Information Only Service Note

Supersedes:
N5173B-07

N5173B X-Series MXG μ Wave Signal Generator

The Problem – Recommending using Refurbishment Part Number for Self Test 1105 and 1304 failures due to excessive reverse power by user.

Figure 1 - A3 RF Output Switch - U13

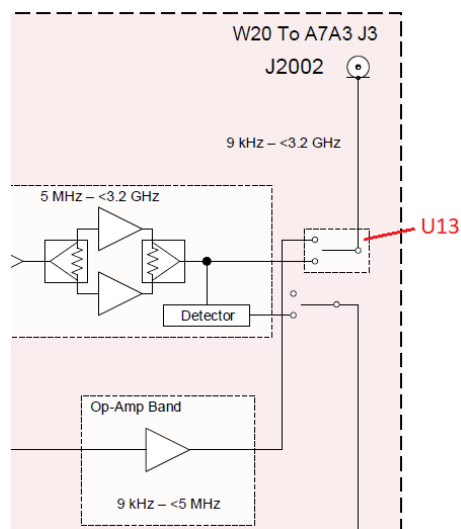
The component level part on the A3 RF assembly that typically gets damaged under these conditions is the RF output solid state switch (U13) as shown in Figure 1, which is taken from a block diagram in the instrument service guide.

When U13 is damaged in this way it may either be stuck in one position or the other, or it may not pass any signals at all.

- a) Replacement part for repair – to use refurbishment part number because the damage is most likely caused by excessive reverse power being applied to the RF output by the user.
